Title			
Size A	Number		Revision
Date:	3/04/2026	Sheet of	
File:	C:\Users\...MCU.SchDoc	Drawn By:

Title		
Size	Number	Revision
A4		
Date:	3/04/2026	Sheet of
File:	C:\Users\...\Boost 12V.SchDoc	Drawn By:

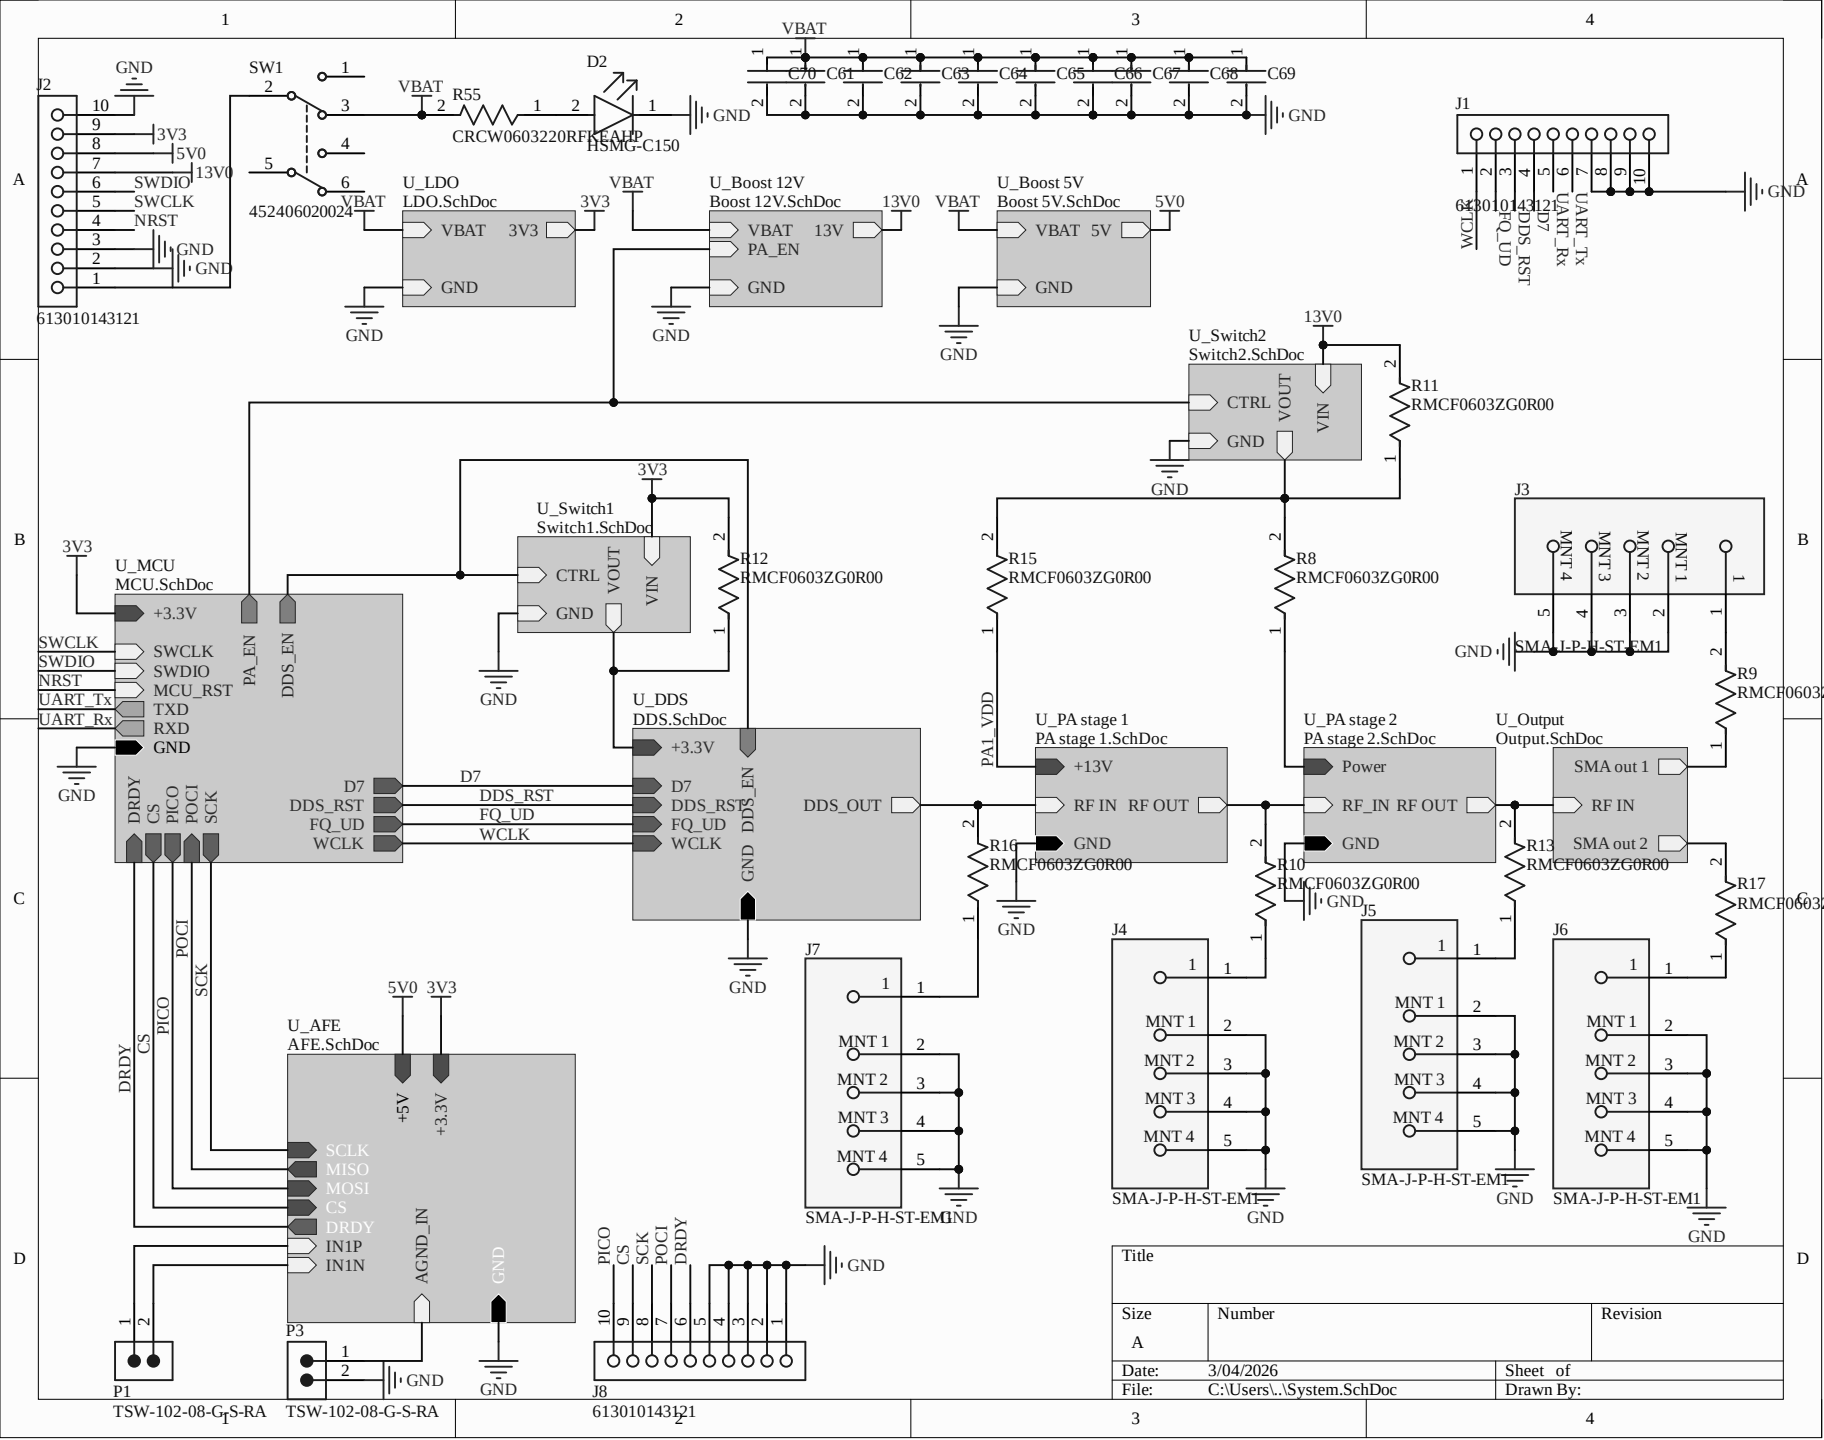
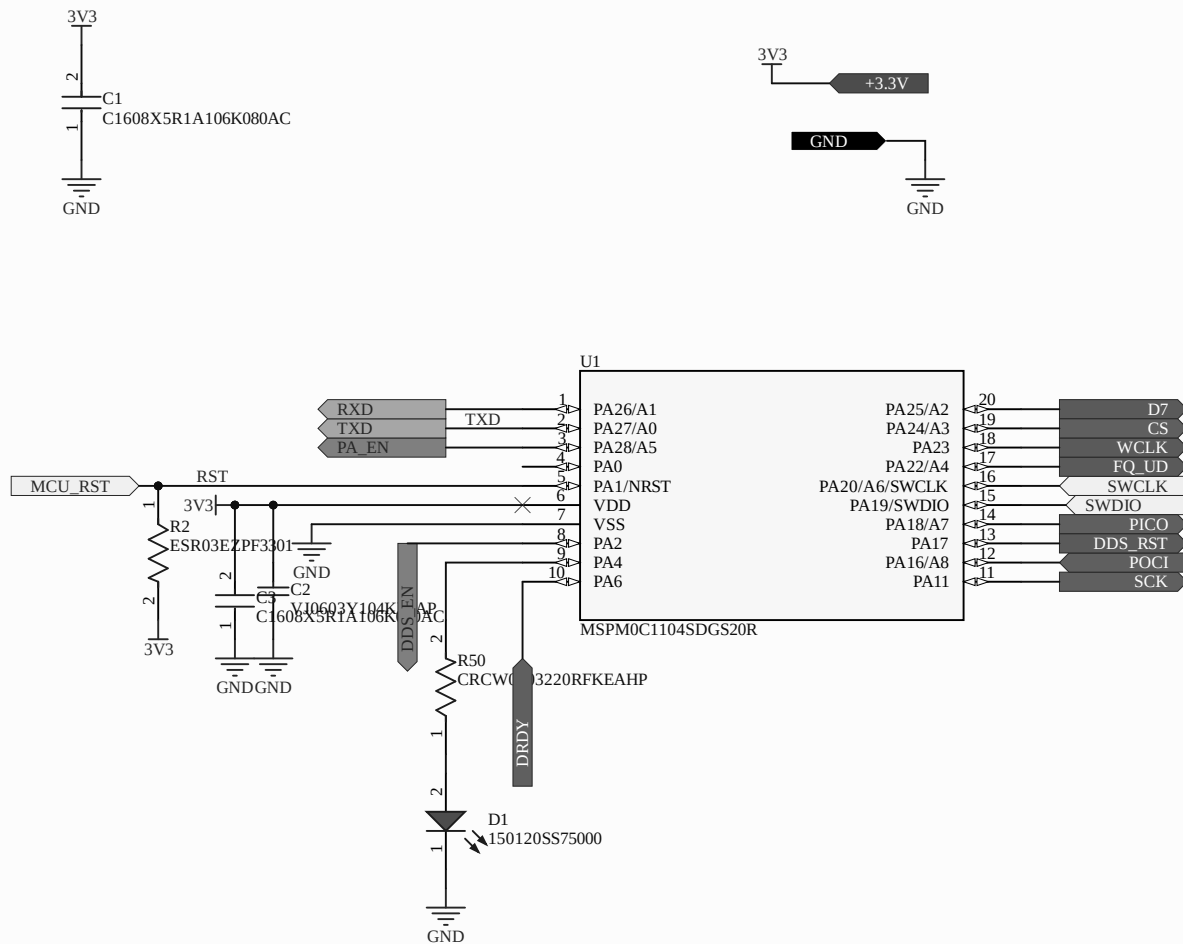
Δ PICO pin is incorrect?
PICO can only be
assigned to pins
14,16,20 but here it's on
pin 13

Title		
Size	Number	Revision
A		
Date:	3/04/2026	Sheet of
File:	C:\Users\...\Switch1.SchDoc	Drawn By:

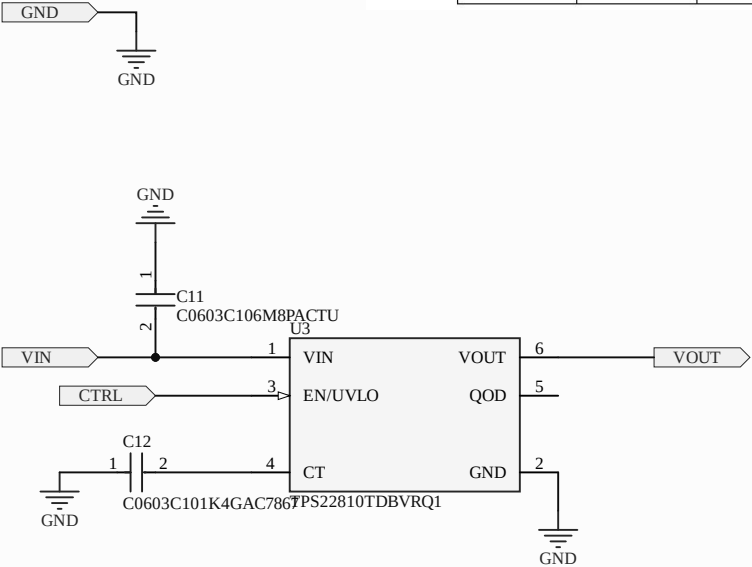
△ QOD can be left floating as no discharging is needed

Title		
Size	Number	Revision
A		
Date:	3/04/2026	Sheet of
File:	C:\Users\...\PA stage 2.SchDoc	Drawn By:

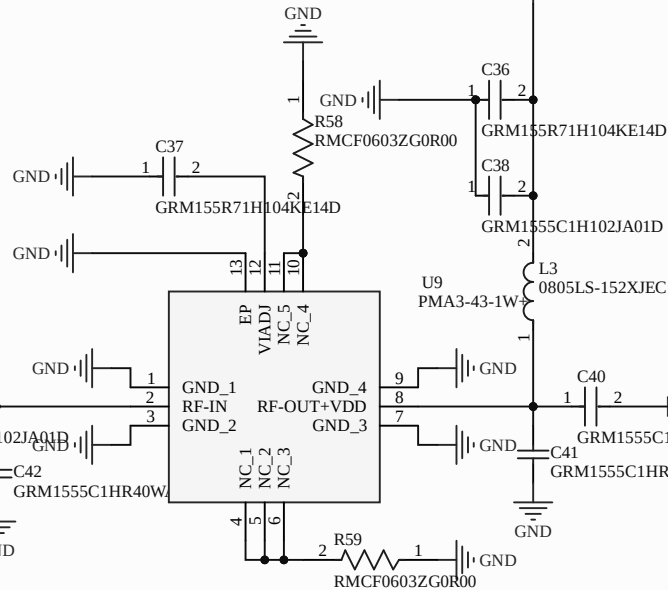
Order the 0805LS-152XJEC inductor from coilcraft
